Project No. 0771-356-11-41
June 5, 2023

Re: Response to 1st Technical Notice of Deficiency Letter – Major Permit Amendment Application
Fort Worth C&D Landfill
Fort Worth, Tarrant County, Texas
MSW Permit No. 1983E
Tracking No. 28325020

NOD1 Table - Permit Type IV (Permit 1983E)

D:\0771\356\EXPANSION 2022\PART III\III-G-D-2-JUNE 2021 GW MAP.dwg, ipubtr, 1:2

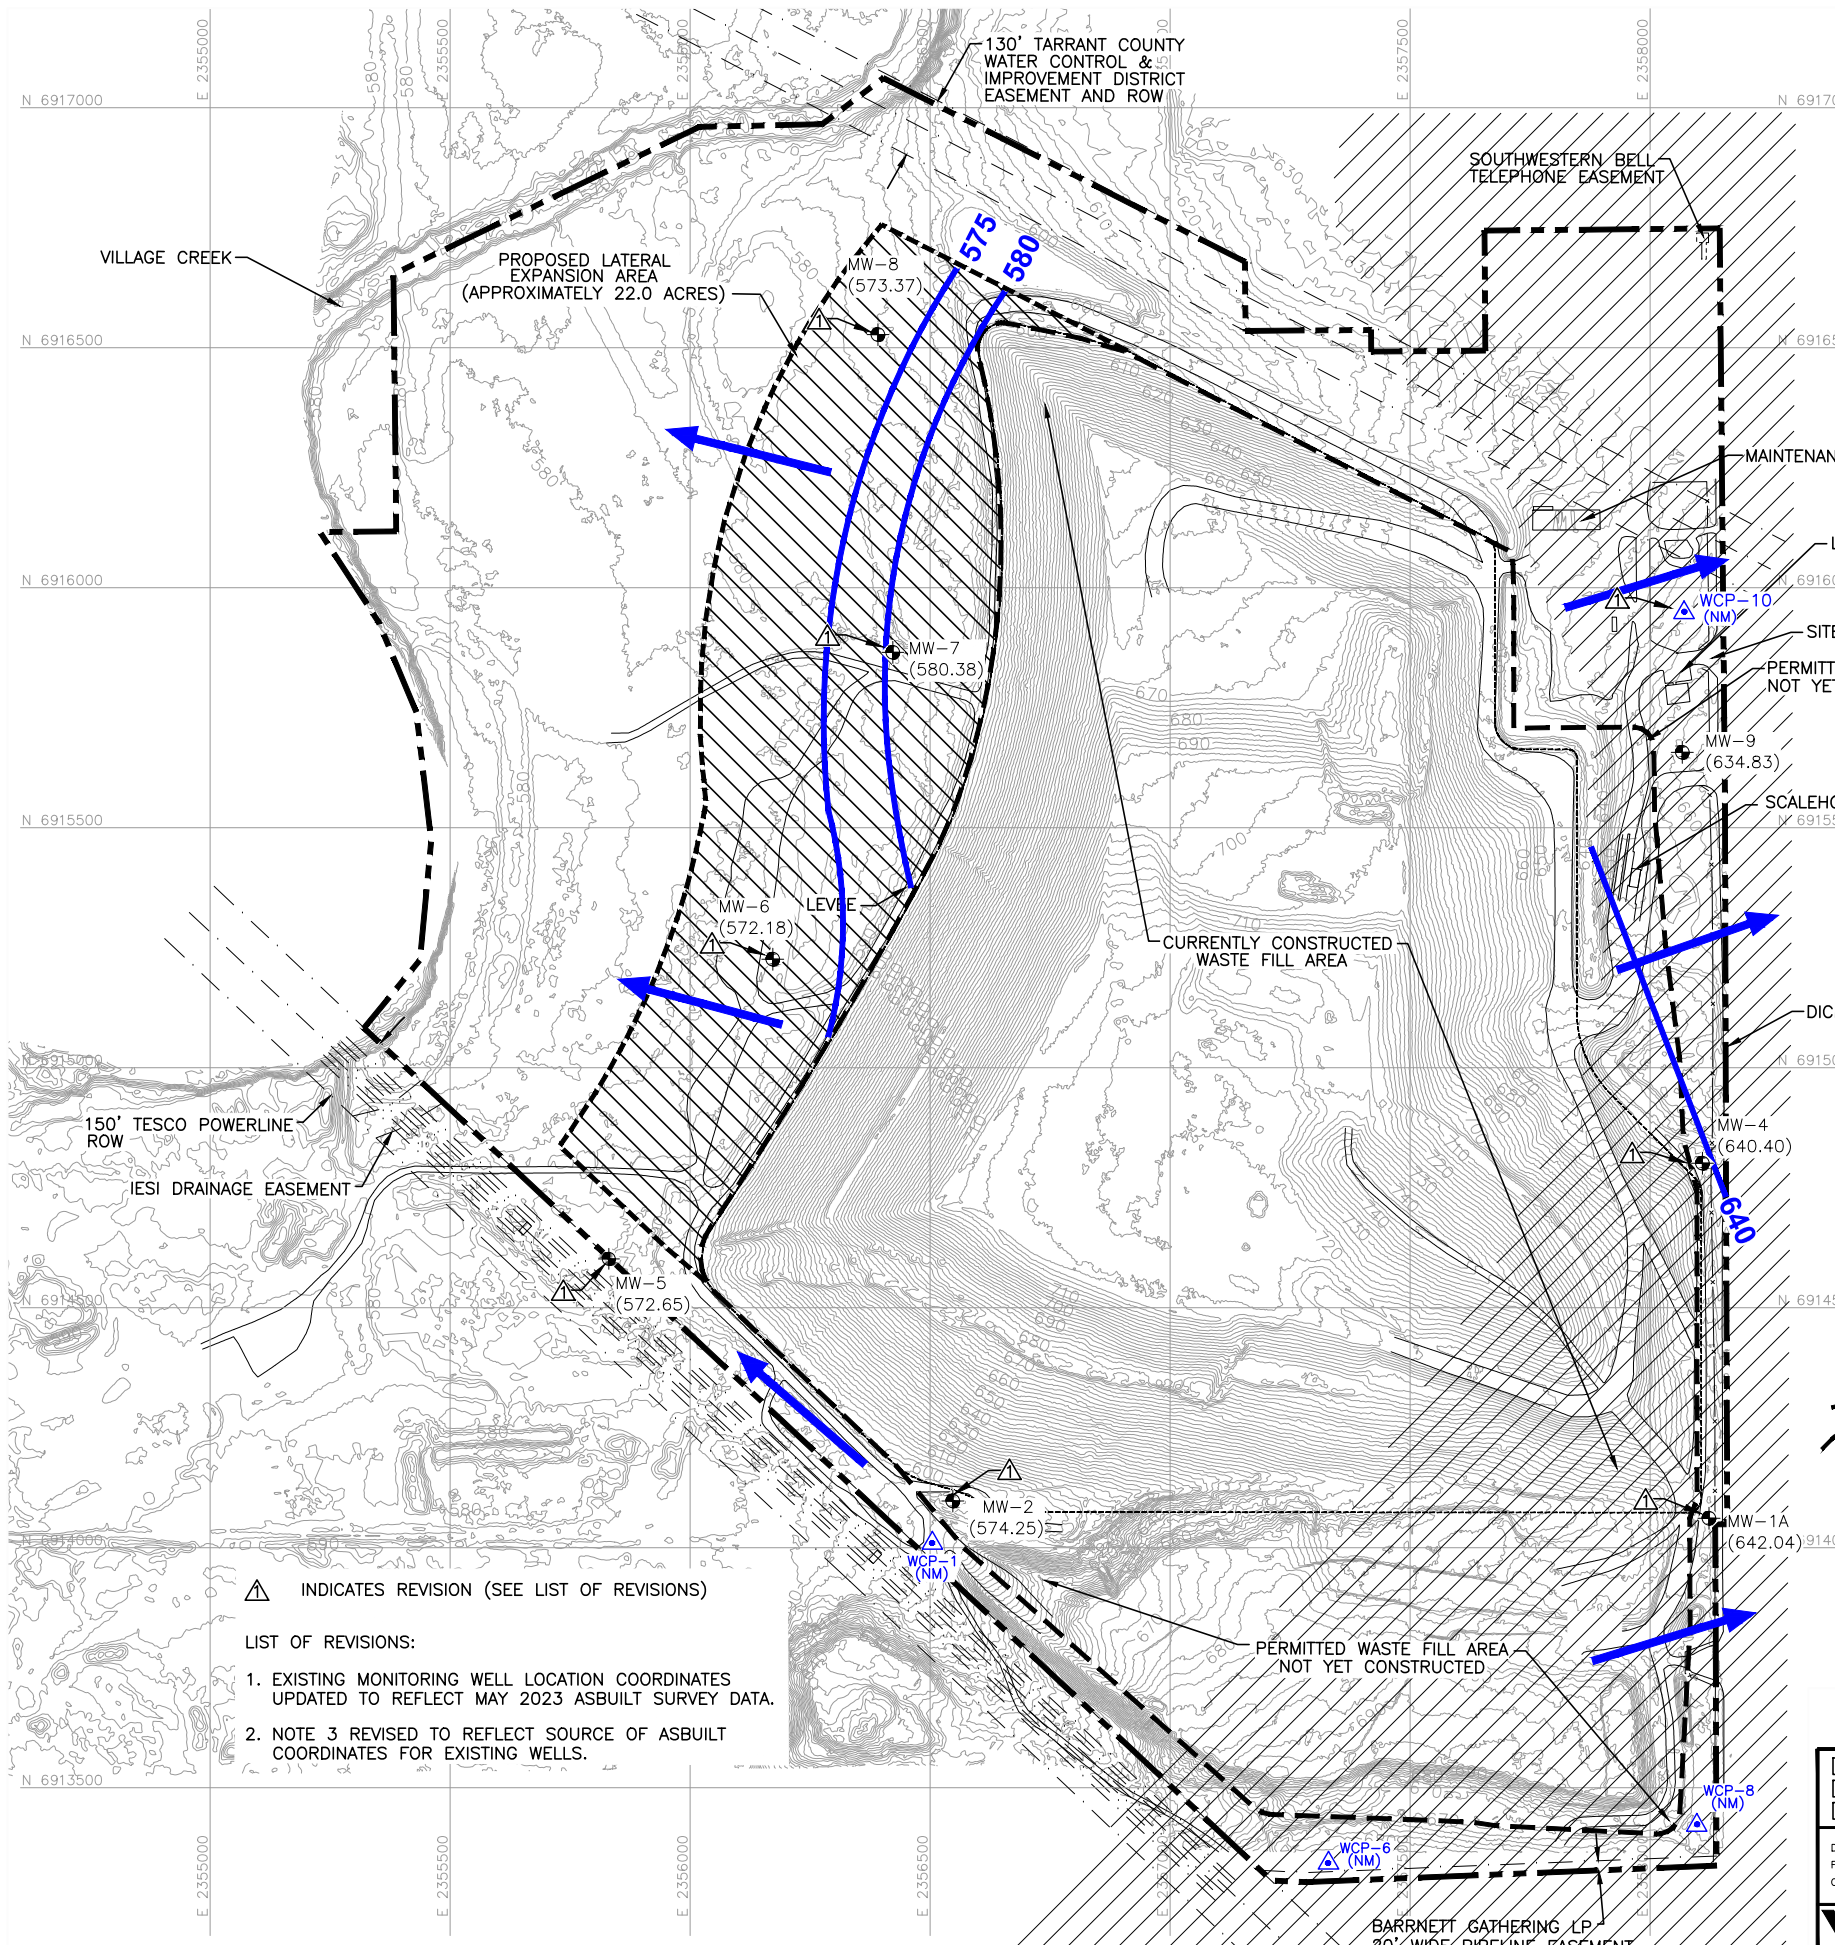
T28	507	Part III	330.63(e)(5)(F)	Ambiguous	<p>Explain the meaning/significance of the Woodbine groundwater contour maps shown on pages IIIG-D-36 through D-38: compare with the cross-sections in Figures IIIG-C-2 through C-9 where the Woodbine formation is missing.</p> <p>Response: The groundwater contour maps on pages IIIG-D-36 through IIIG-D-38 were obtained from the facility's Annual Groundwater Monitoring Reports by The Carel Corporation from the facility's June 2020, 2021, and 2022 monitoring events. Inquiry into these maps indicate that the Woodbine Formation was omitted from consideration in the development of the contours depicted on these maps. However, the groundwater elevation data are accurate and consistent with historical groundwater elevations and were contoured by WCG, consistent with the facility's permitted hydrogeological characterization, as depicted on existing Figures IIIG-D-1 through IIIG-D-3 in Appendix IIIG.</p>
